Moorhead Area Public Schools  
Sports Center North Rink Mechanical Upgrades  
Moorhead, MN

ZBA Project No. 25-029

Date: February 9, 2026

### ADDENDUM B

2 NORTH RINK FIREWALL ELEVATION  
SCALE: 1/8" = 1'-0"

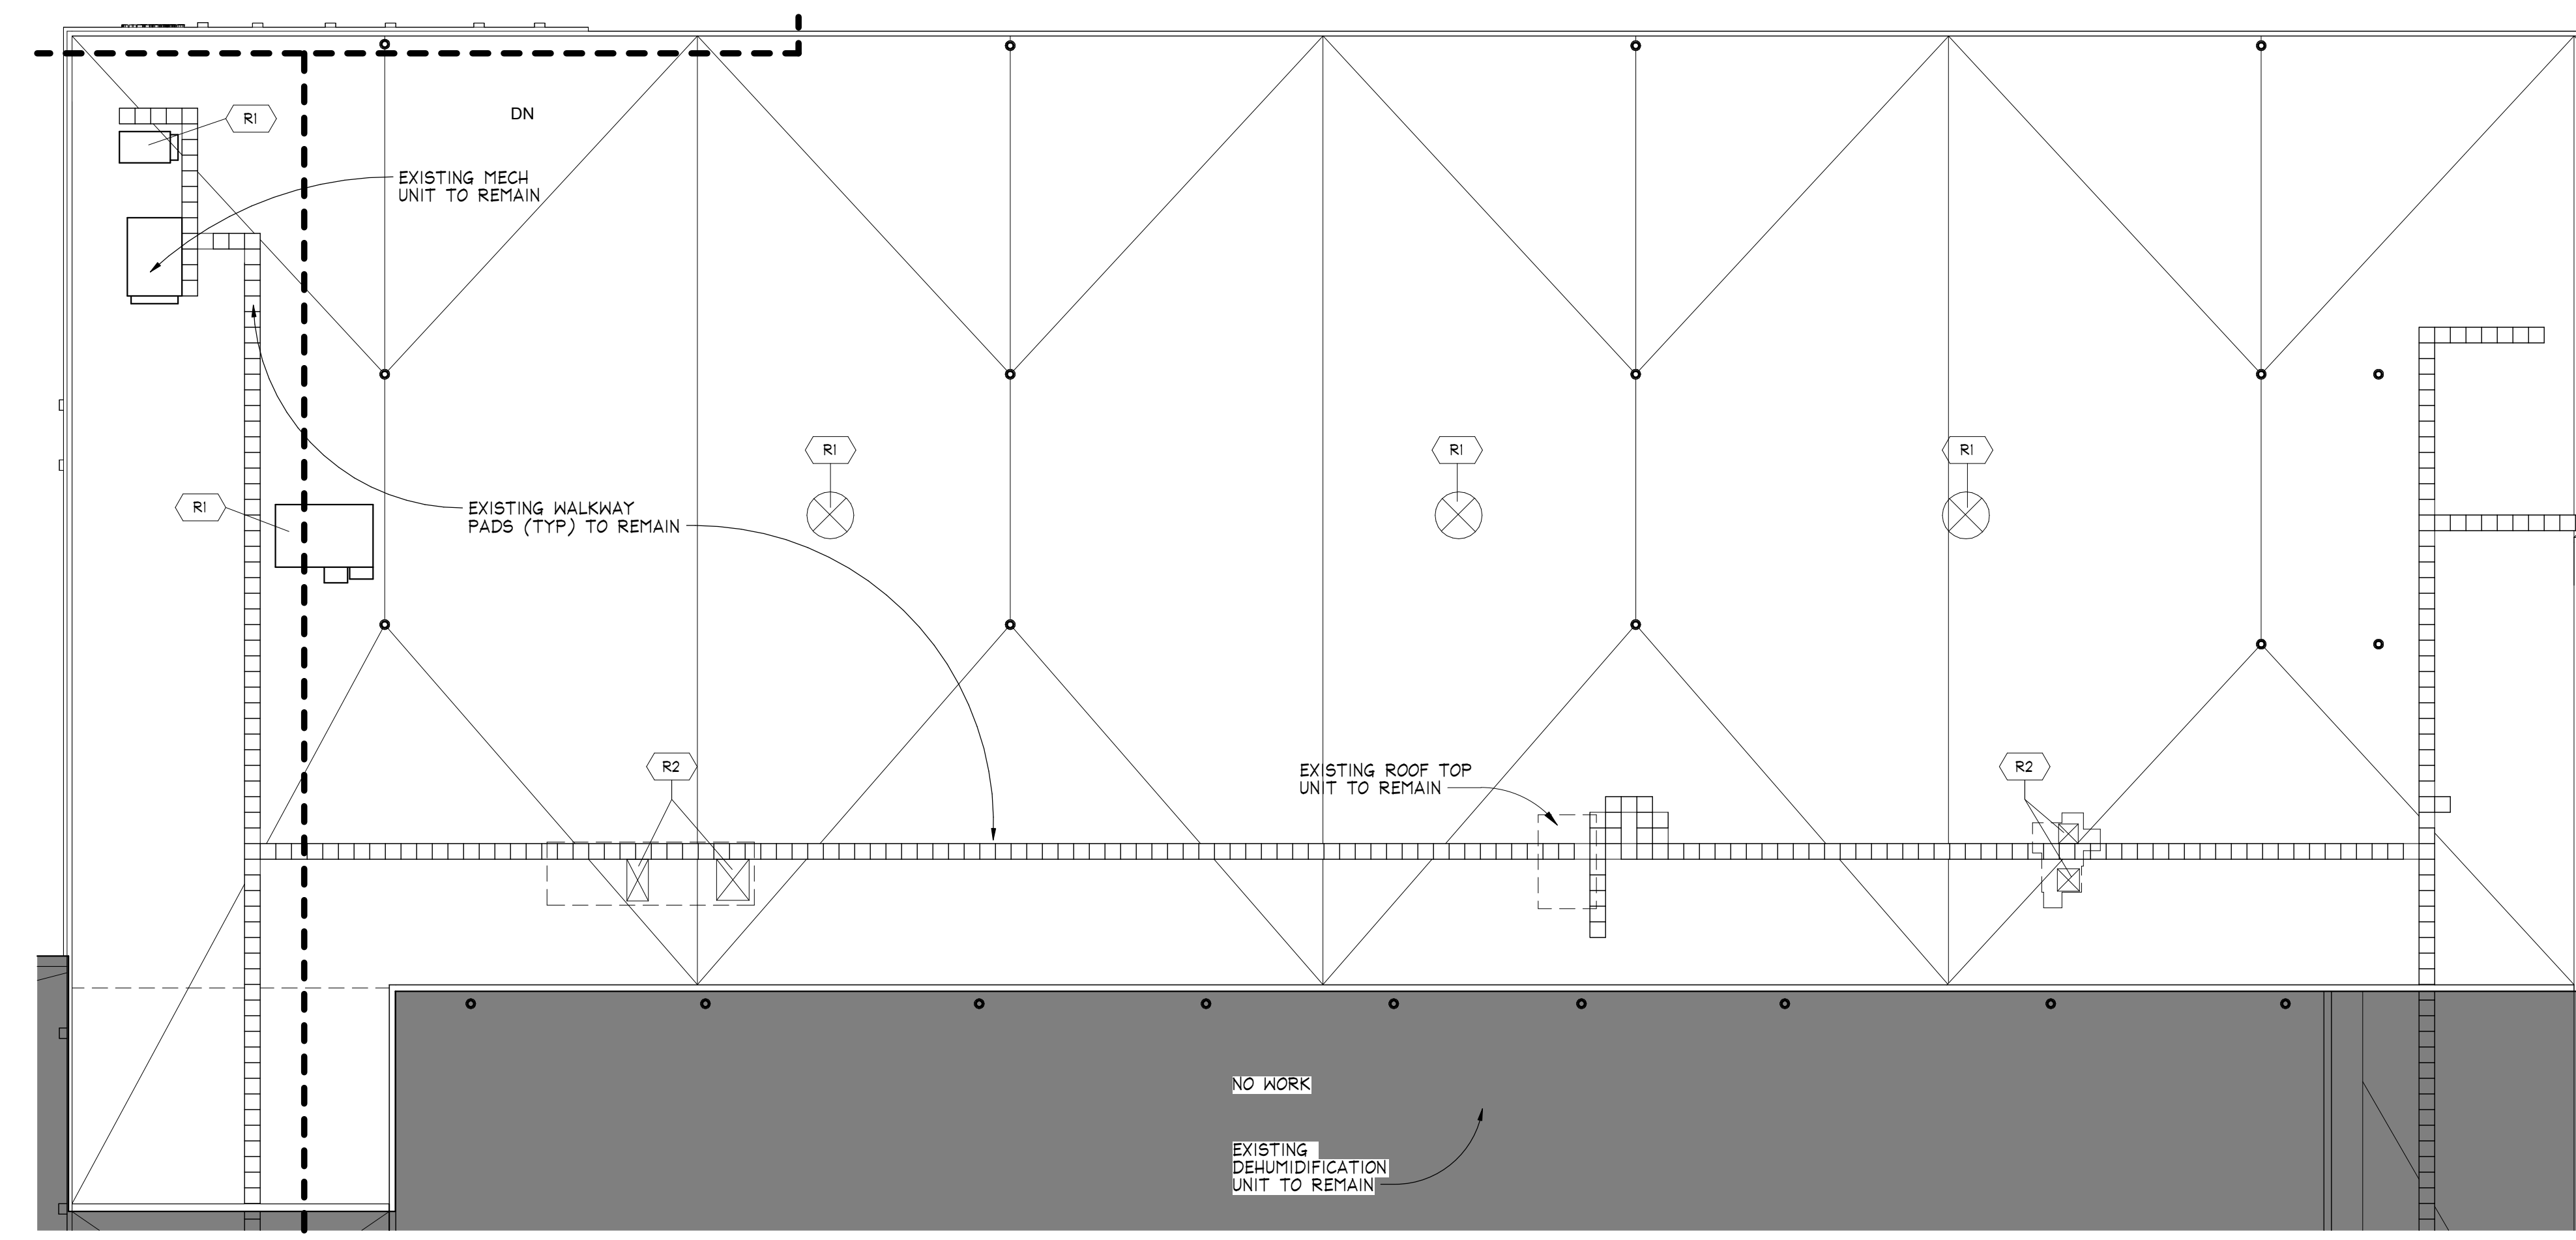
1. Interior Elevation 2/A3.00: Add control joints as shown.

IMAGE 1  
SOUTH INTERIOR WALL & COLUMN LINE  
(LOOKING WEST)

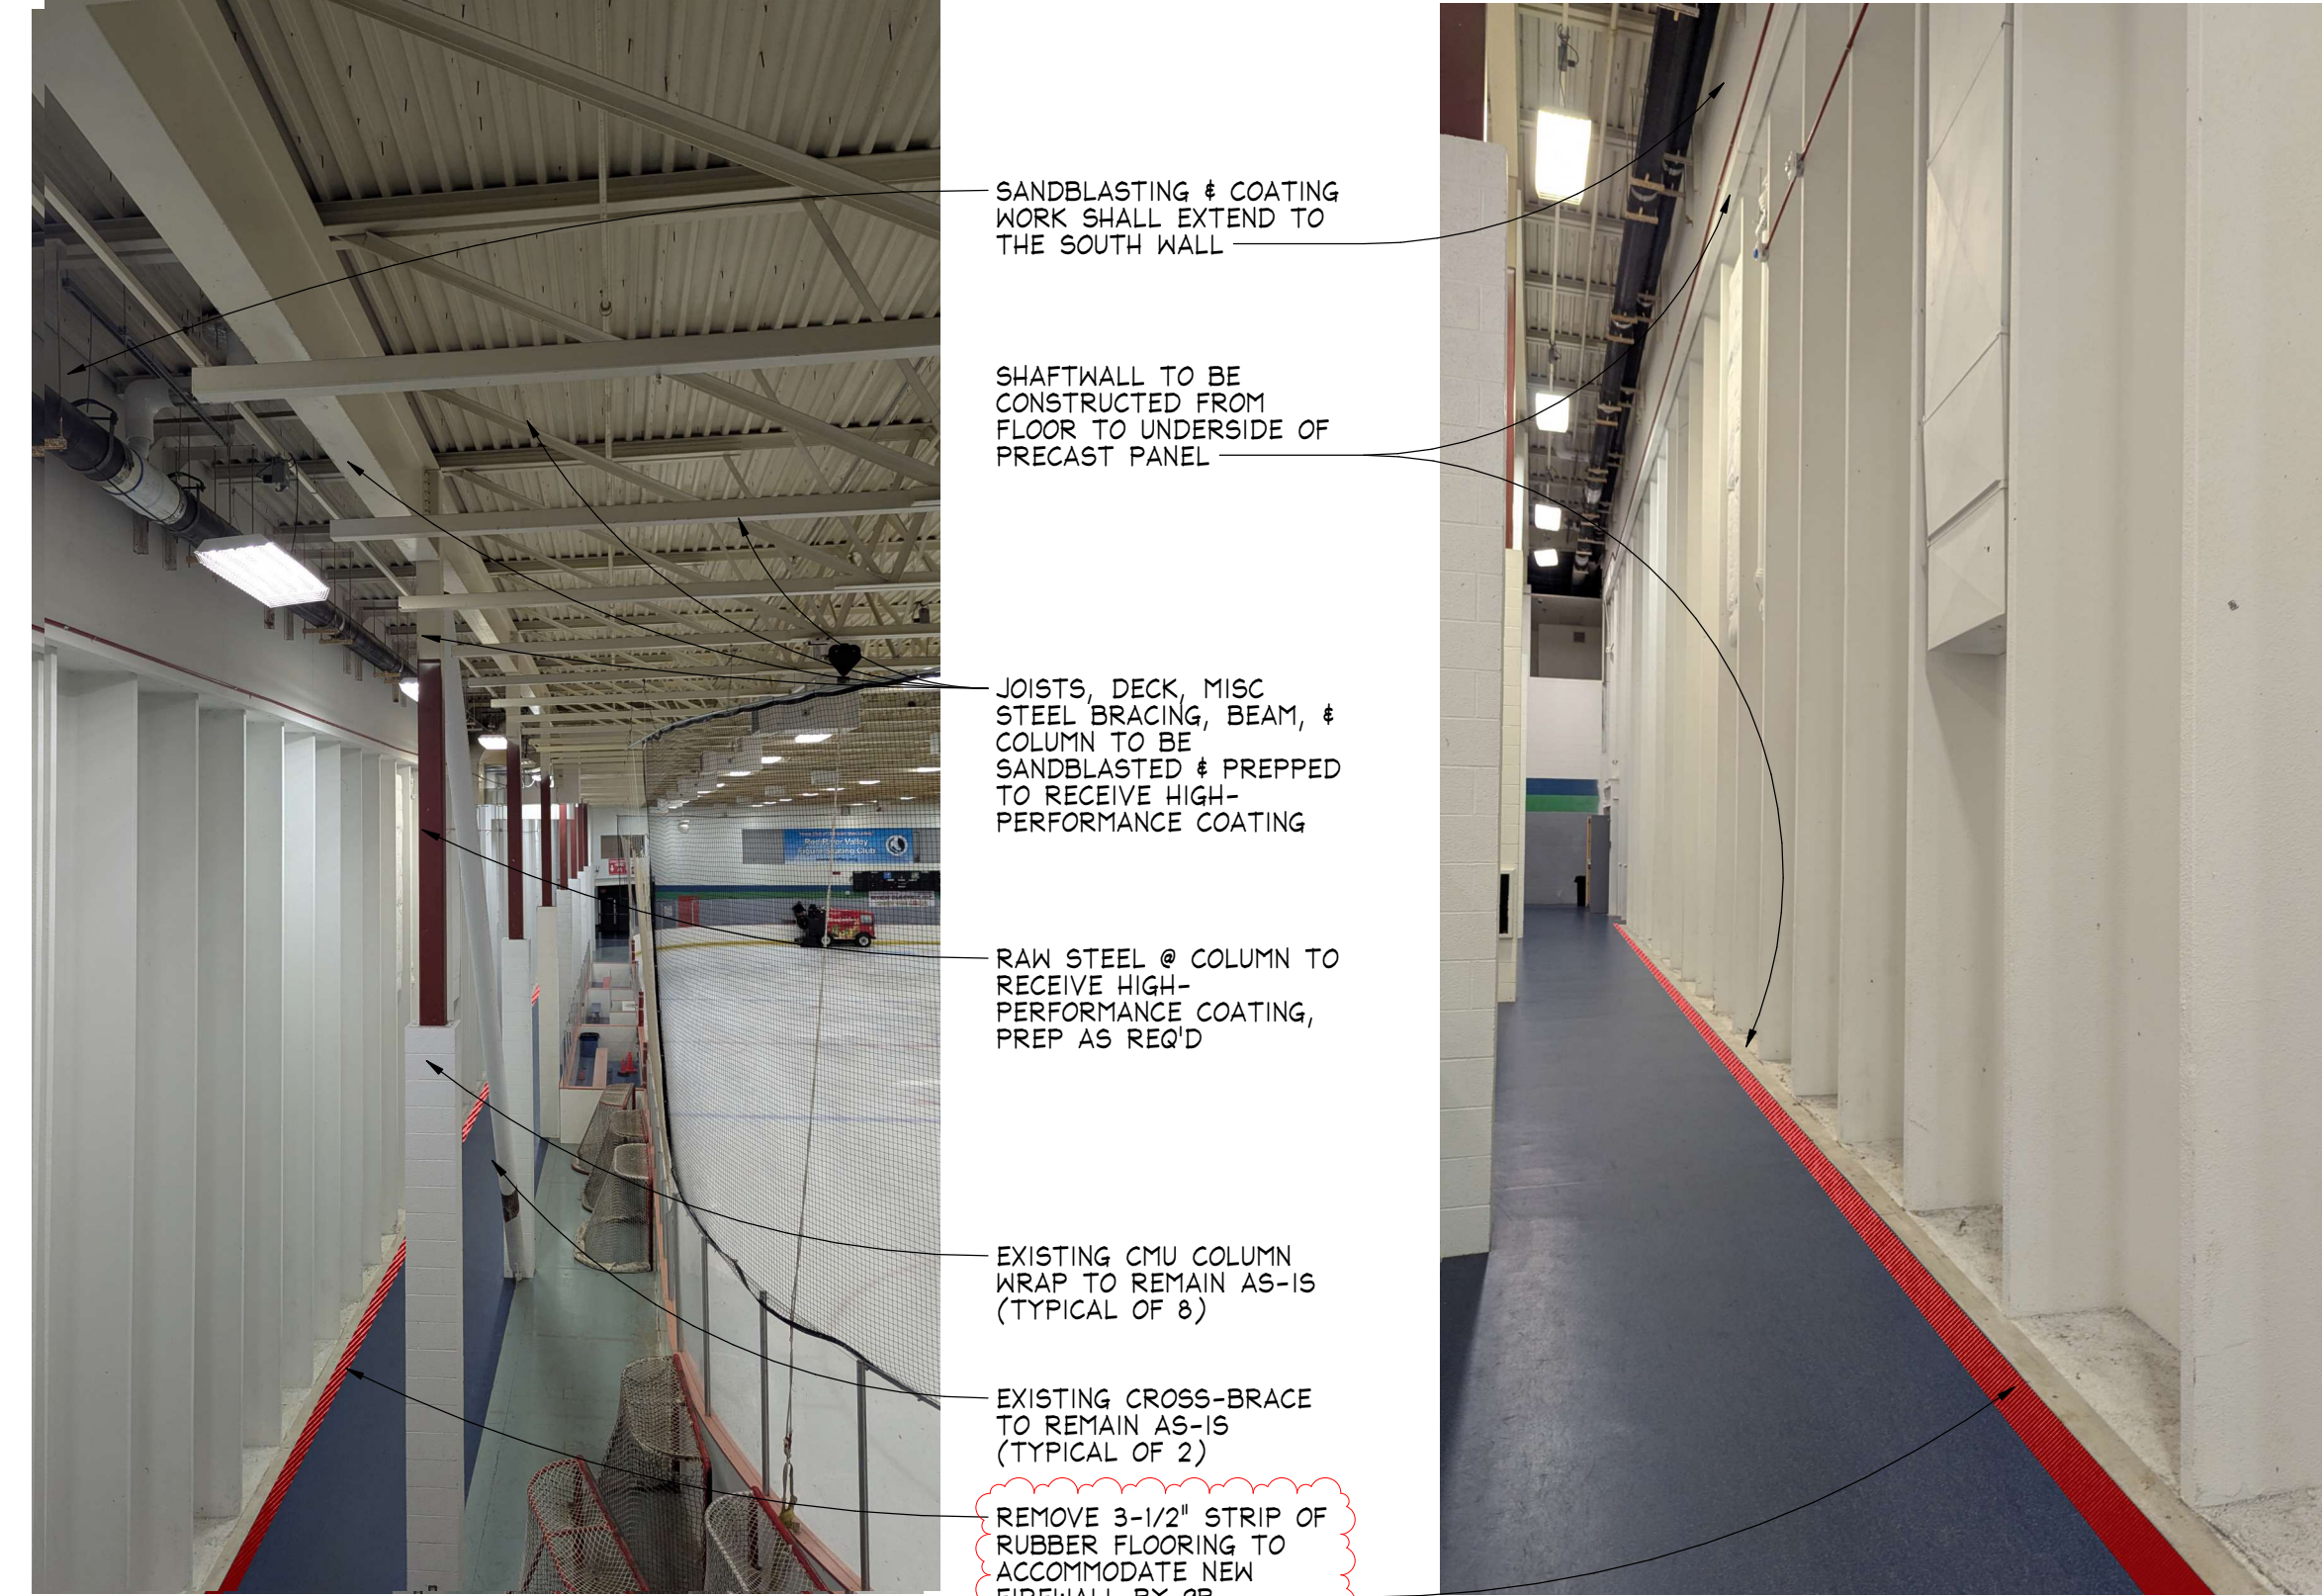
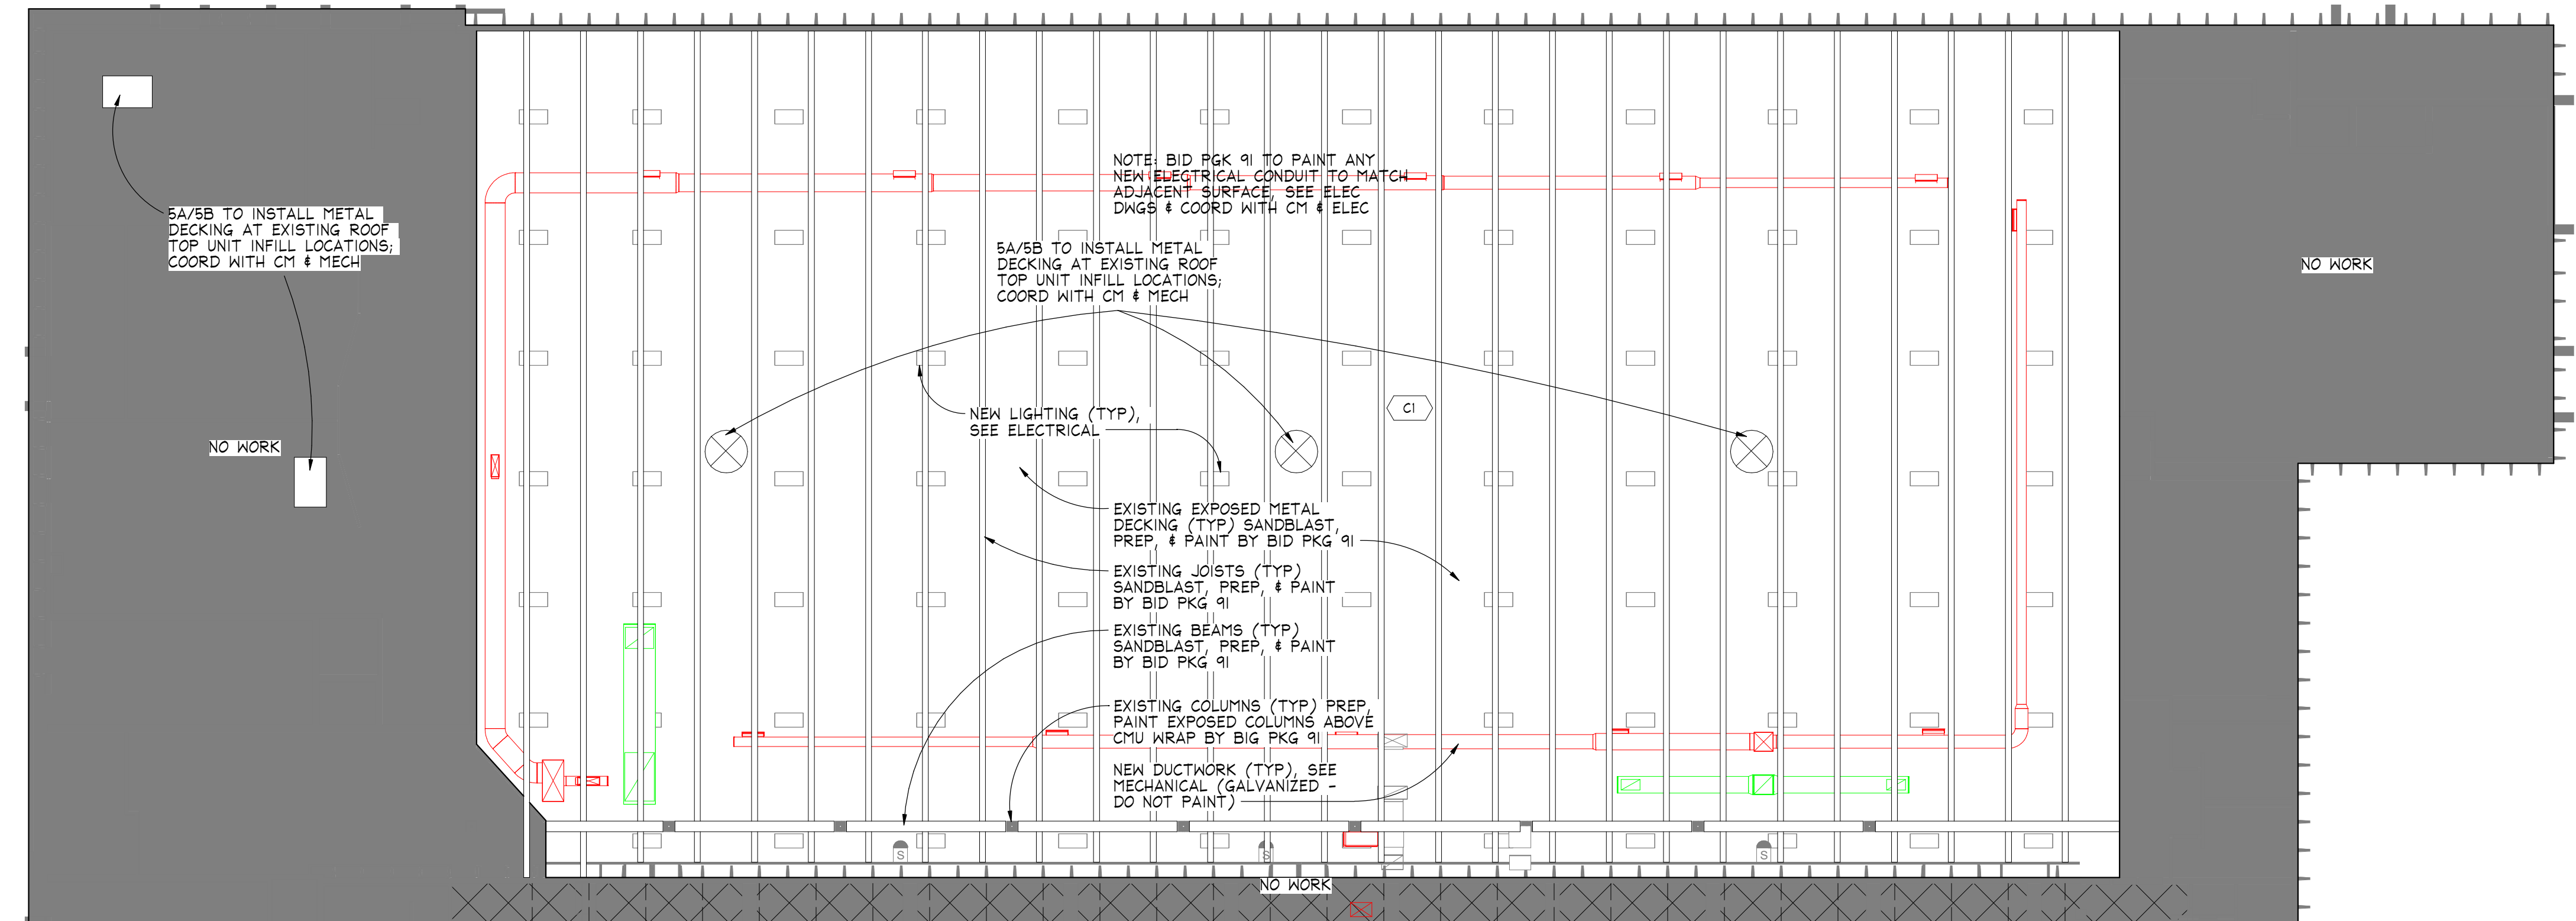
1. Main and Second Level Floor Plans 1 & 2/A3.01: Revise notes.
2. Images 1 & 2: Add demolition note.
